**SUBJECT: PALO VERDE NUCLEAR GENERATING STATION, UNITS 1, 2, AND 3 -
STAFF ASSESSMENT OF INFORMATION PROVIDED UNDER TITLE 10 OF
THE *CODE OF FEDERAL REGULATIONS* PART 50, SECTION 50.54(f),
SEISMIC HAZARD REEVALUATIONS FOR RECOMMENDATION 2.1 OF THE
NEAR-TERM TASK FORCE REVIEW OF INSIGHTS FROM THE FUKUSHIMA
DAI-ICHI ACCIDENT AND STAFF CLOSURE OF ACTIVITIES ASSOCIATED
WITH RECOMMENDATION 2.1, "SEISMIC" (CAC NOS. MF5277, MF5278 AND
MF5279)**

STAFF ASSESSMENT BY THE OFFICE OF NUCLEAR REACTOR REGULATION

RELATED TO SEISMIC HAZARD AND SCREENING REPORT

PALO VERDE NUCLEAR GENERATING STATION, UNITS 1, 2, AND 3

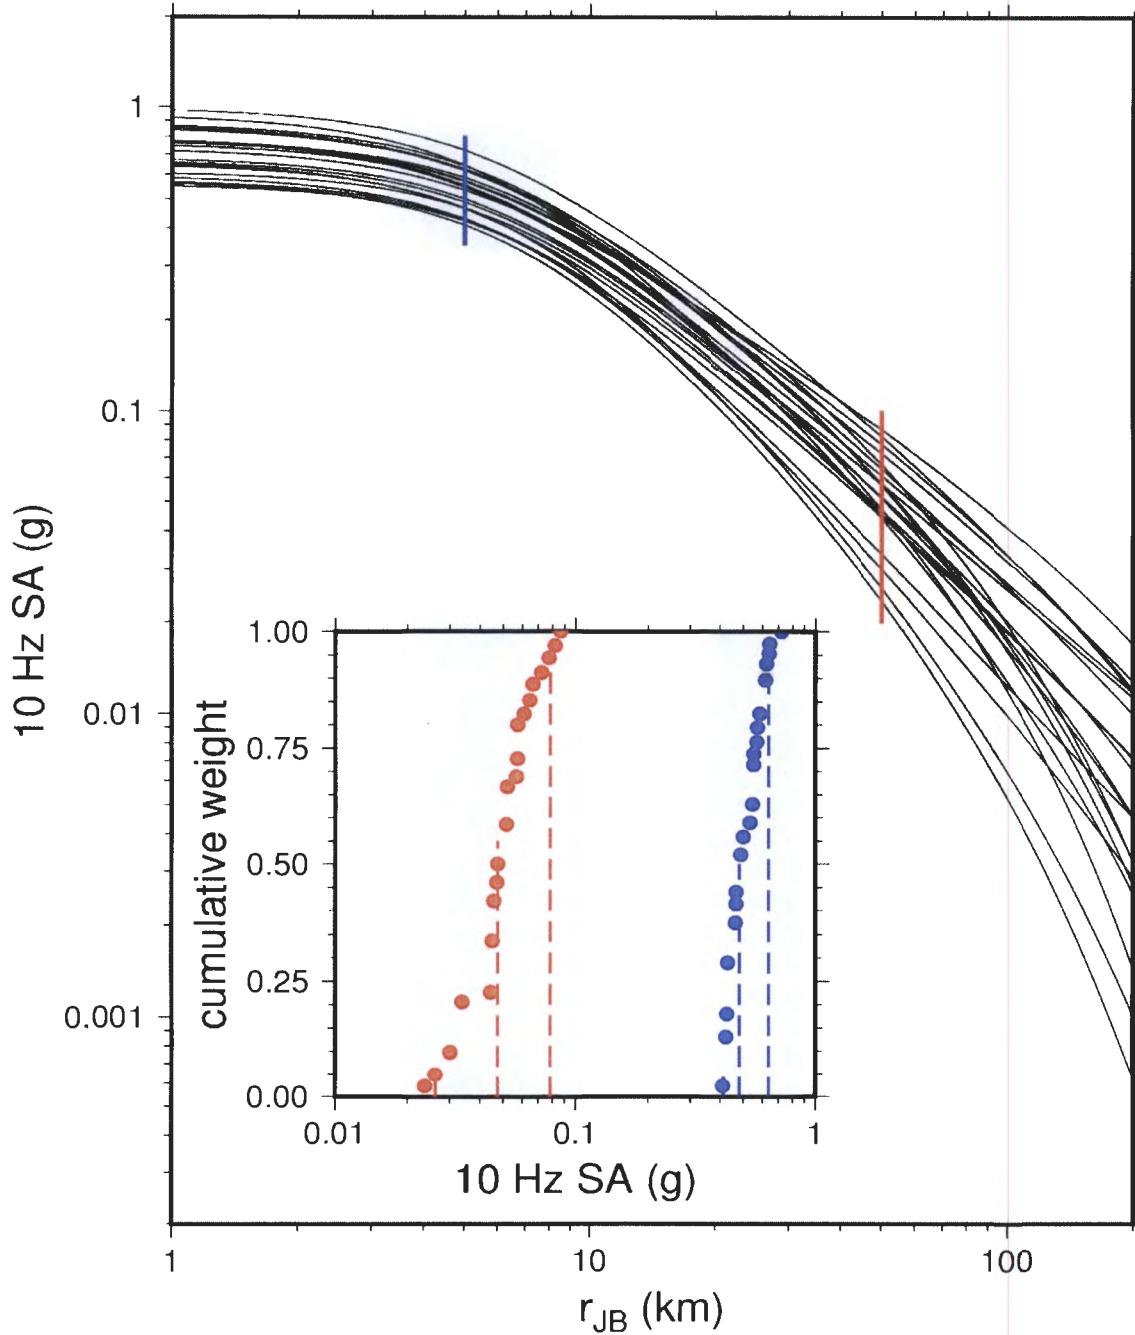
To evaluate the distributions of median spectral accelerations predicted by the two sets of GMPEs, the NRC staff examined the behavior of the models for multiple earthquake magnitude and source-to-site distance combinations. Figure 3.2.3-1 of this assessment shows the distribution of weighted medians produced by the set of GMPEs using the Sammon's map approach for the Arizona sources. Specifically, Figure 3.2.3-1 shows the distribution of weighted median results from the 21 of the 45 GMPEs developed for 10 Hz spectral acceleration from a **M6** earthquake for source-to-site distances ranging from 1 to 200 km. Shown in the inset to Figure 3.2.3-1 are the cumulative distributions of weighted median values for two vertical slices through the 21 weighted medians at source-to-site distances of 5 km (blue) and 50 km (red). As shown by the two cumulative distributions at 5 km and 50 km, the 21 predicted weighted medians are centered at reasonable values (0.05g for 50 km and 0.50g for

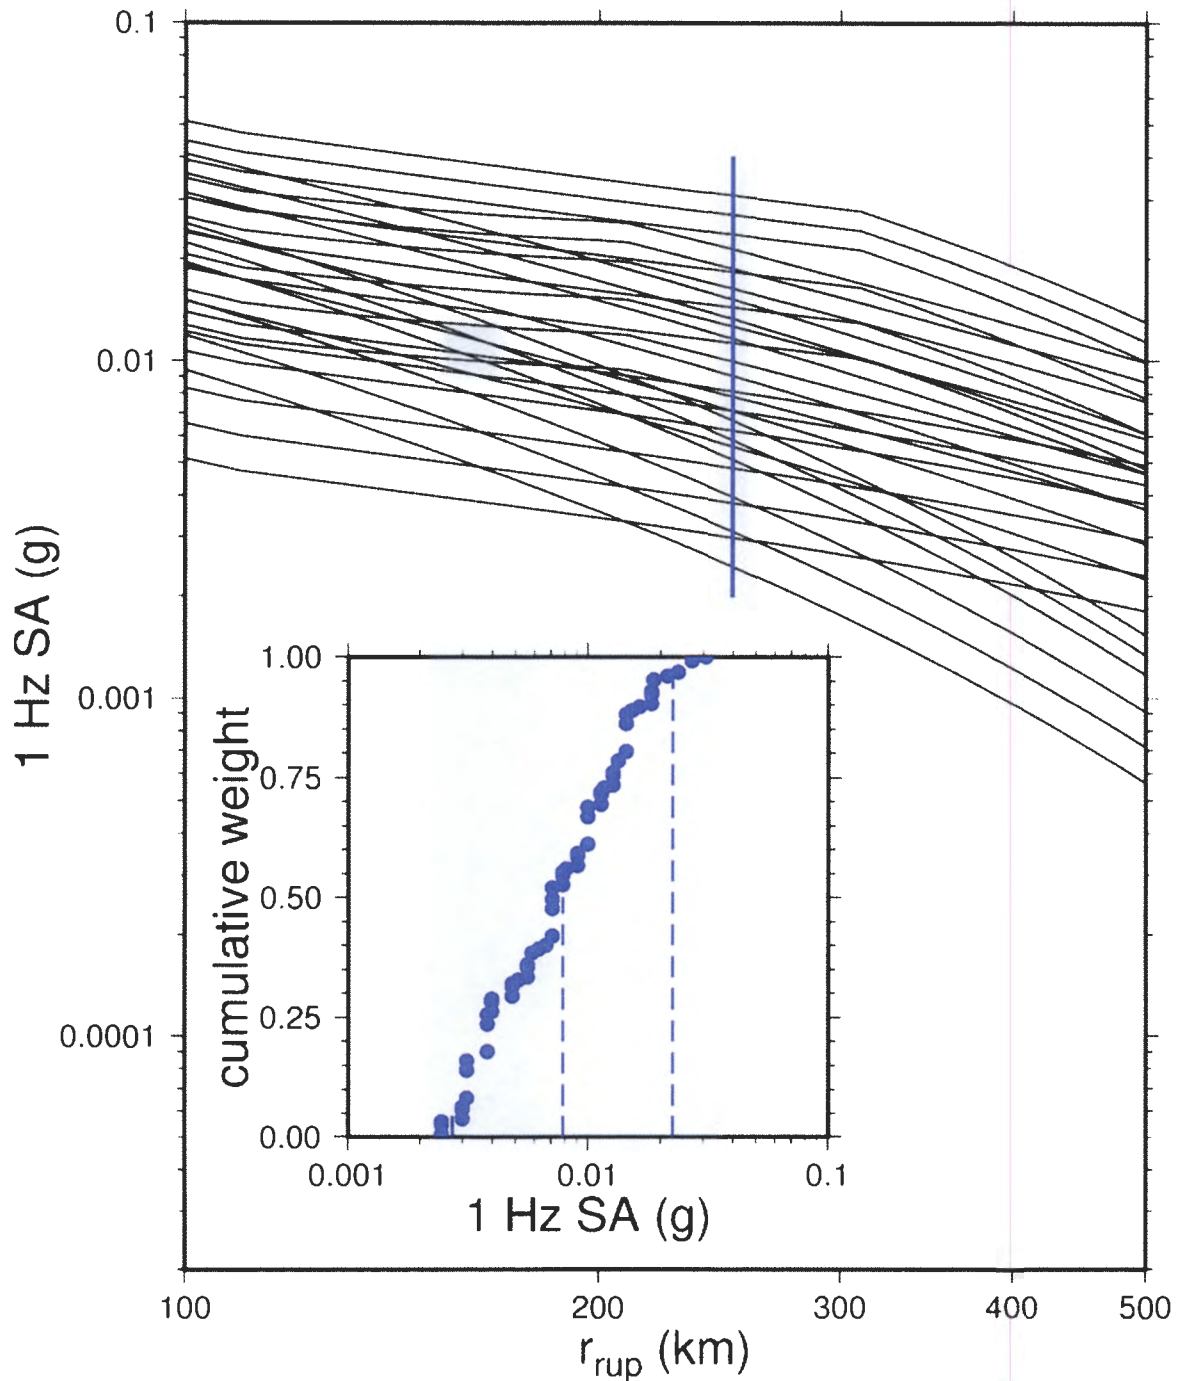
Similarly, Figure 3.2.3-2 of this assessment shows the distribution of weighted medians produced by the set of GMPEs developed by the TI Team for the distant California and Mexico sources. Specifically, Figure 3.2.3-2 shows the distribution of weighted median results from the 60 GMPEs developed for 1 Hz spectral acceleration from a **M7.5** earthquake for source-to-site distances ranging from 100 to 500 km. Shown in the insert to Figure 3.2.3-2 is the cumulative distribution of weighted median values for a vertical slice through the 60 weighted medians at a source-to-site distance of 250 km. As shown by the cumulative distribution at a distance of 250 km, the 60 predicted weighted medians are centered at reasonable value (0.008g) and cover a suitably wide range of 1 Hz spectral accelerations (0.002g to 0.030g).

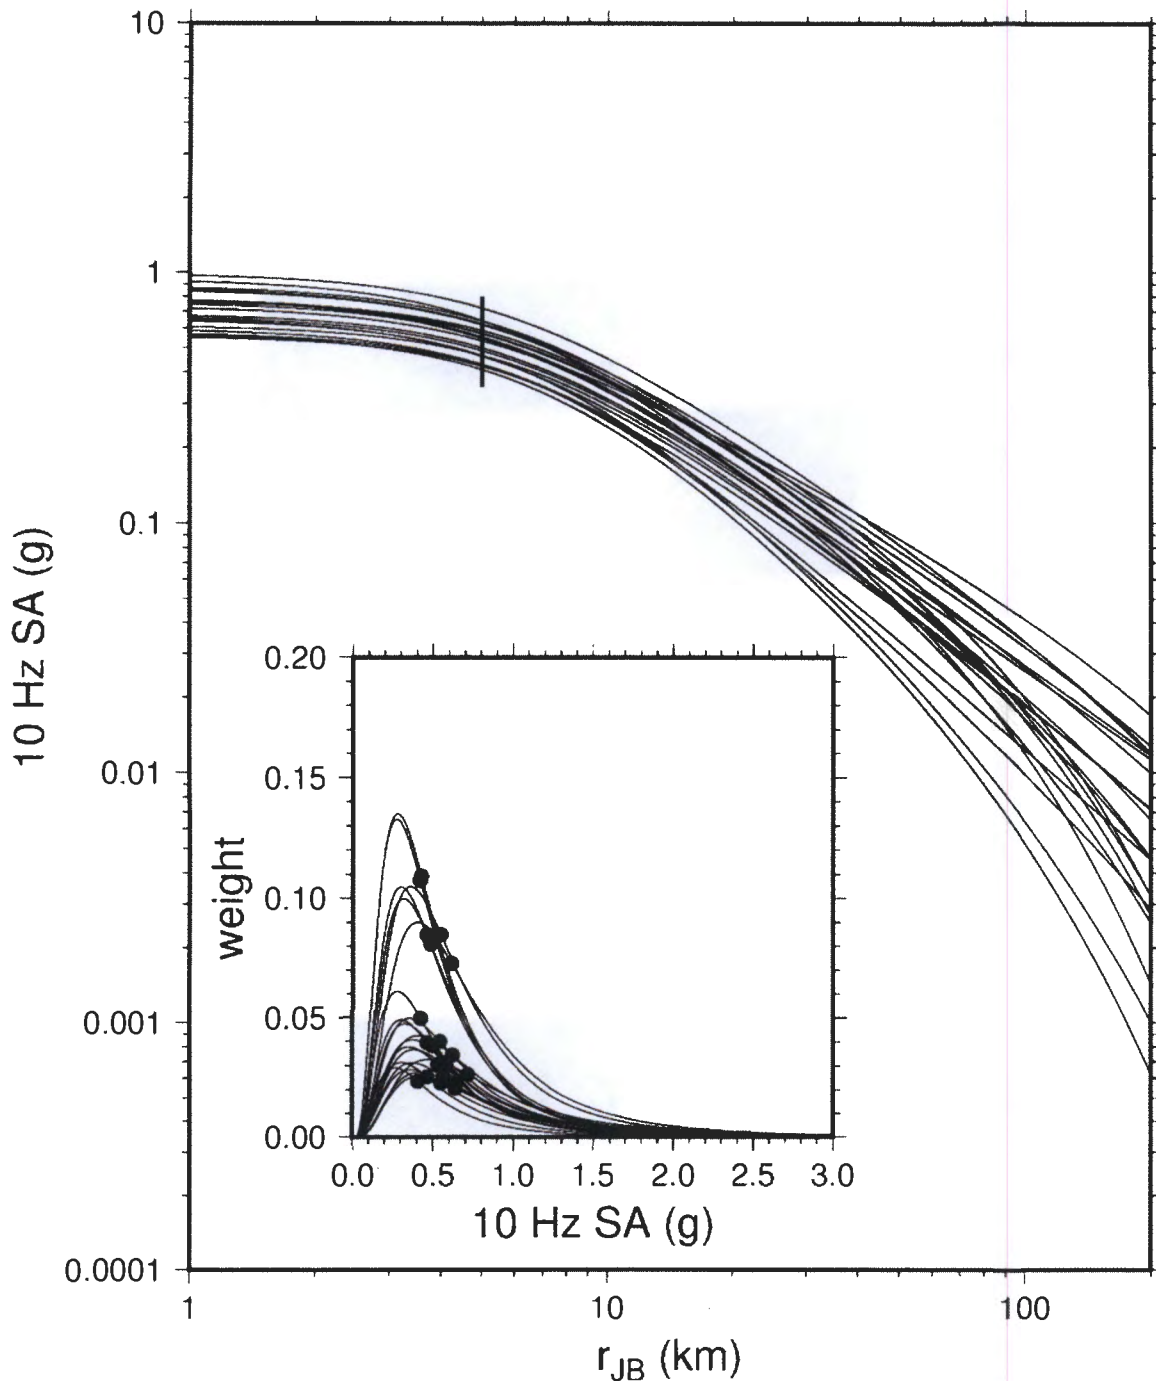
To evaluate the ground motion variability about the predicted median spectral accelerations, the NRC staff examined the behavior of the ground motion distributions for multiple earthquake magnitude and distance combinations. Figure 3.2.4-1 of this staff assessment shows the GMPEs for 10 Hz spectral accelerations from a **M6** earthquake over a distance range of 1 to 200 km. The inset to Figure 3.2.4-1 shows the weighted distributions of 10 Hz spectral accelerations in terms of the median (dots) and single station sigma values for a vertical slice at a distance of 5 km. As shown by the 21 models for this particular scenario earthquake (i.e., **M6** at a distance of 5 km), the weighted distributions cover a wide range of 10 Hz spectral accelerations from about 0.03g to about 1.5g.

The staff notes that Figure 3.2.4-1 shows the multiple distributions of 10 Hz spectral acceleration using only the middle branch (i.e., median) for single-station sigma. Not shown are the additional distributions of 10 Hz spectral accelerations for the low (5th percentile) and high (95th percentile) values of single-station sigma. In addition, Figure 3.2.4-1 shows only 21 of the 45 GMPEs developed by the TI Team for 10 Hz spectral acceleration for the regional Arizona sources. In total, there are 135 individual weighted distributions (45 medians x 3 sigmas) for the spectral frequency of 10 Hz. Similarly, there are 120 to 150 unique distributions developed by the TI Team for each of the other 21 spectral frequencies. For the California and Mexico sources, the TI Team developed 360 individual weighted distributions (60 medians x 6 sigmas) for each of the spectral acceleration frequencies. The additional three sigmas for the distant sources capture the unique source-to-site path effects from the California and Mexico scenario earthquakes. The staff finds that the TI Team's use of this large number of distributions for each of the spectral frequencies adequately captures the epistemic and aleatory uncertainty in predicted ground motions for PVNGS.

Figure 3.3.2-1. Location of the virtual faults for the SBR (blue) and TZ (brown) areal source zones (outlined in black). For the confirmatory analysis, the staff placed virtual faults more densely around the PVNGS site (red triangle) and more sparsely out to a distance of 250 km.

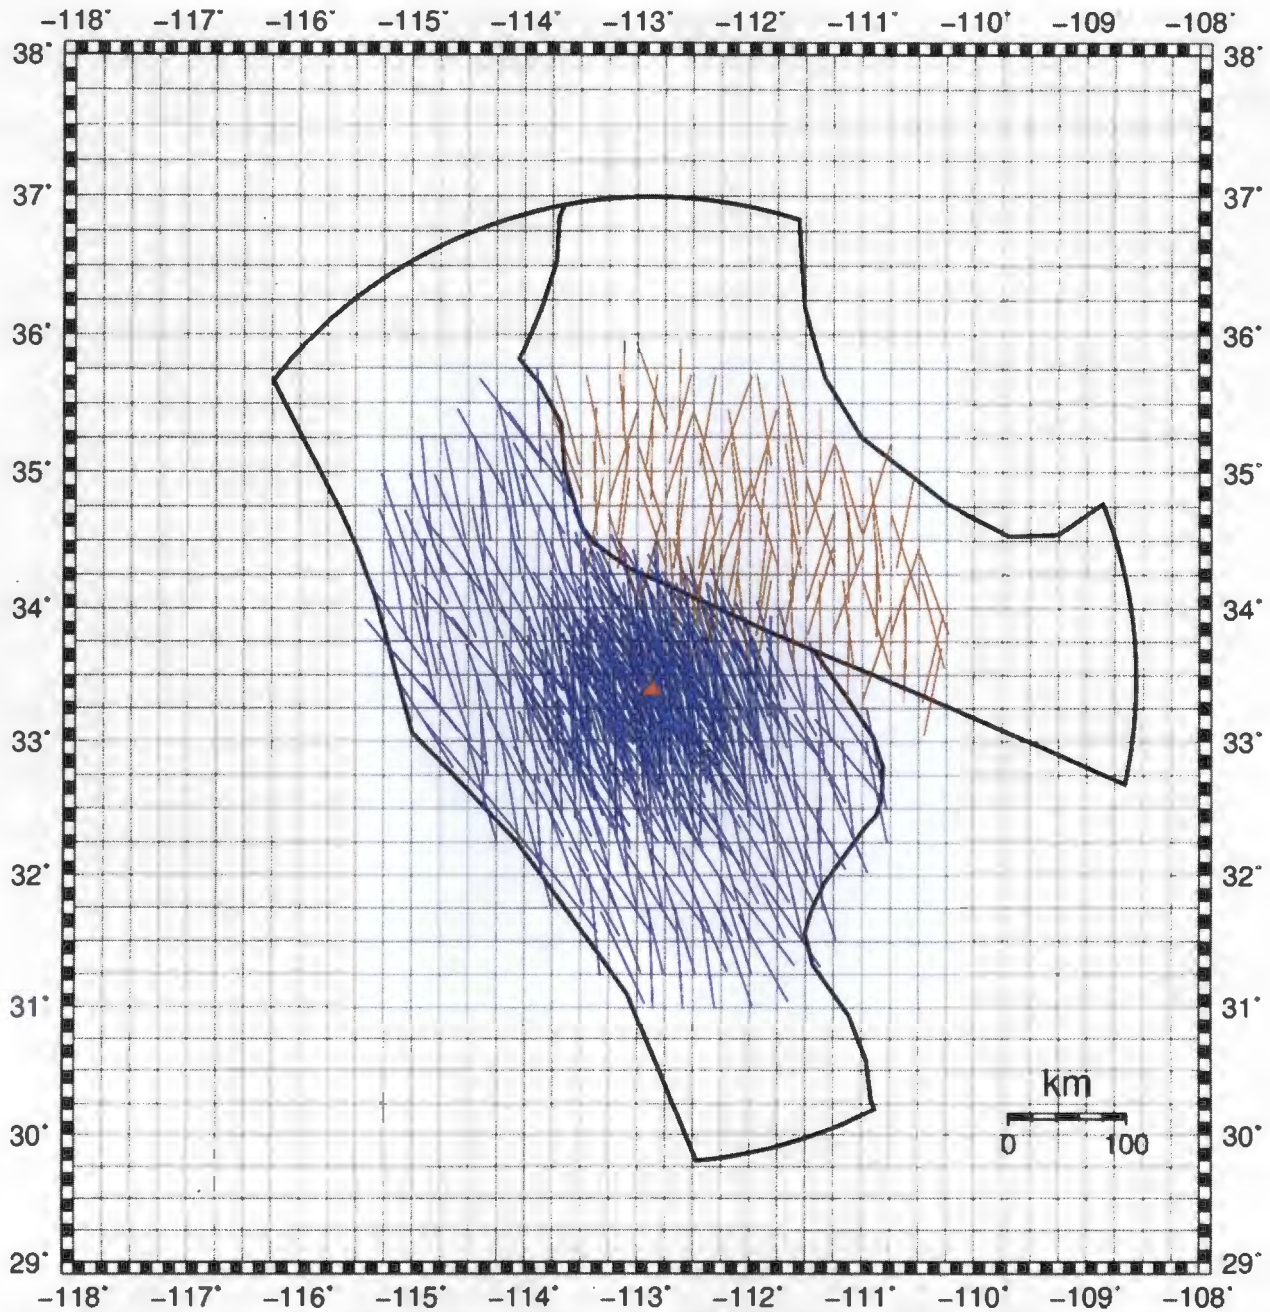
Figure 3.3.2-1 of this staff assessment shows the location of the virtual faults for the SBR (blue) and TZ (brown) areal source zones. For the analysis, the staff placed virtual faults more densely around the PVNGS site (red triangle) and more sparsely out to a distance of 250 km. The staff used this placement of virtual faults to adequately capture the entire range of possible source-to-site distances. Shown in Figure 3.3.2-1 are the virtual faults for the normal faulting mechanism, with each fault having a length of about 65 km and a down-dip width of about 20 km. To represent the structural characteristics of the source zones the staff selected a fault orientation randomly between N40°W and N-S for the SBR. For TZ, the staff selected fault orientations randomly between N20°W to N20°E.

Figure 3.3.2-2. Mean hazard curves for the SBR (blue lines) and TZ (brown lines) areal sources. The staff's PSHA confirmatory analysis results are shown by the solid heavy lines, and the licensee's results are shown by the dashed heavy line.

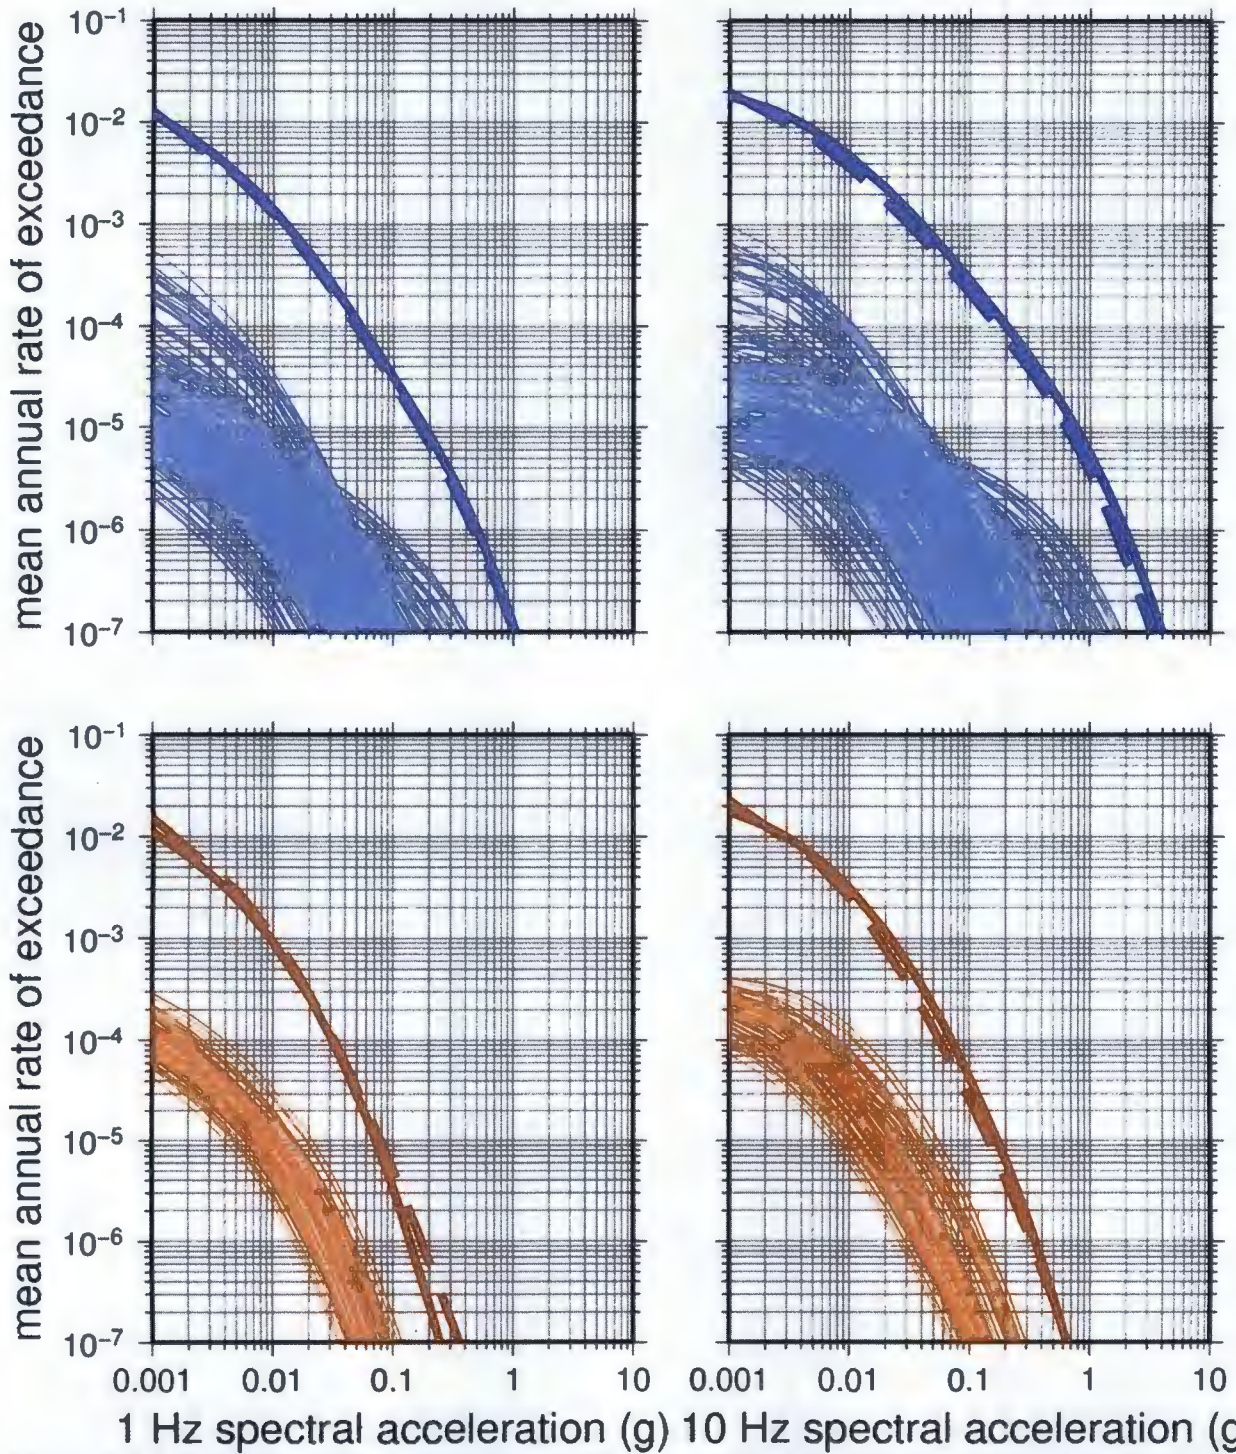
Figure 3.3.2-2 of this staff assessment shows the 1 Hz (left) and 10 Hz (right) mean hazard curves for the SBR (blue) and TZ (brown) areal sources. The staff's PSHA confirmatory results are shown by the solid heavy line with the licensee's results shown by the dashed heavy line. To obtain the final confirmatory results, the staff added up the hazard curves for each of the virtual faults (377 for SBR and 83 for TZ). As shown in Figure 3.3.2-2, the staff's confirmatory results closely match the licensee's results for both the 1 and 10 Hz mean hazard curves.

Figure 3.4.1-1. Shallow seismic velocity profiles used by the NRC staff in confirmatory analyses for the PVNGS site.

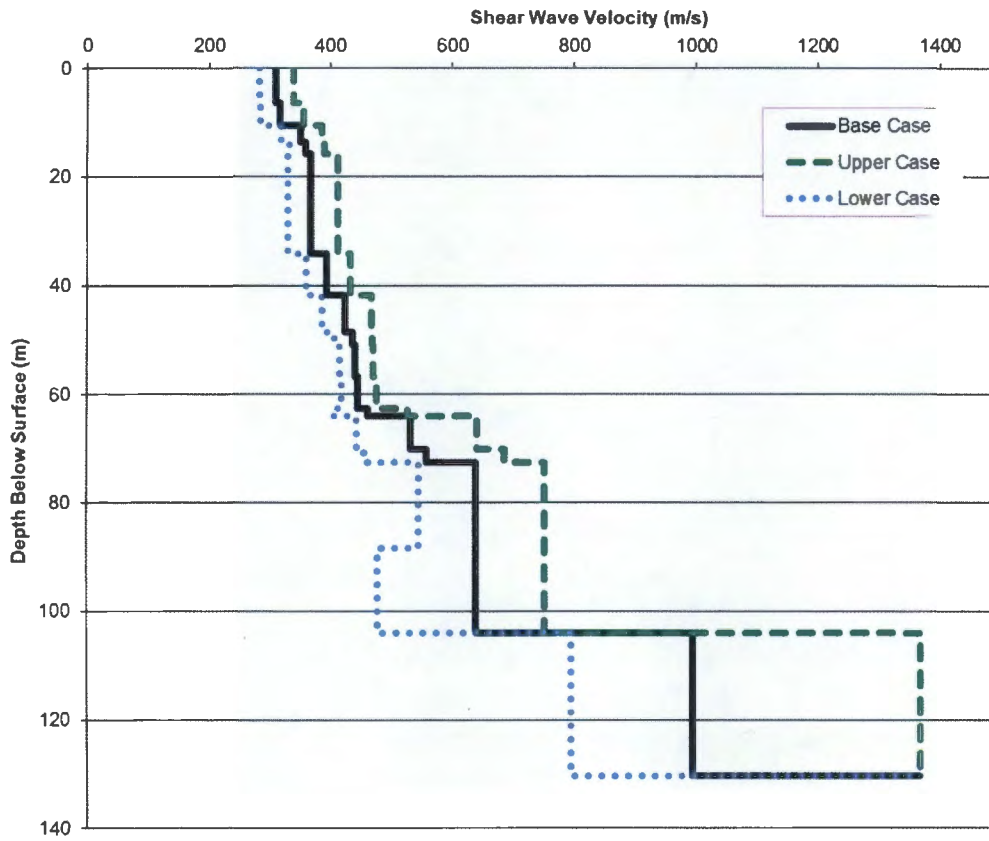
To evaluate the licensee's site response analysis, the NRC staff performed a confirmatory site response analyses for the PVNGS site. Because the licensee had recently completed extensive geophysical testing of the PVNGS site, the staff adopted the licensee's shallow site velocity profiles for use in its confirmatory analysis. The staff performed 60 randomizations of the site profiles using information provided in the SHSR about the variability of the subsurface. To account for uncertainty in depth-to-baseroack, the staff randomized this depth by ± 20 percent. Figure 3.4.1-1 shows the site velocity profiles used in staff's confirmatory analysis.
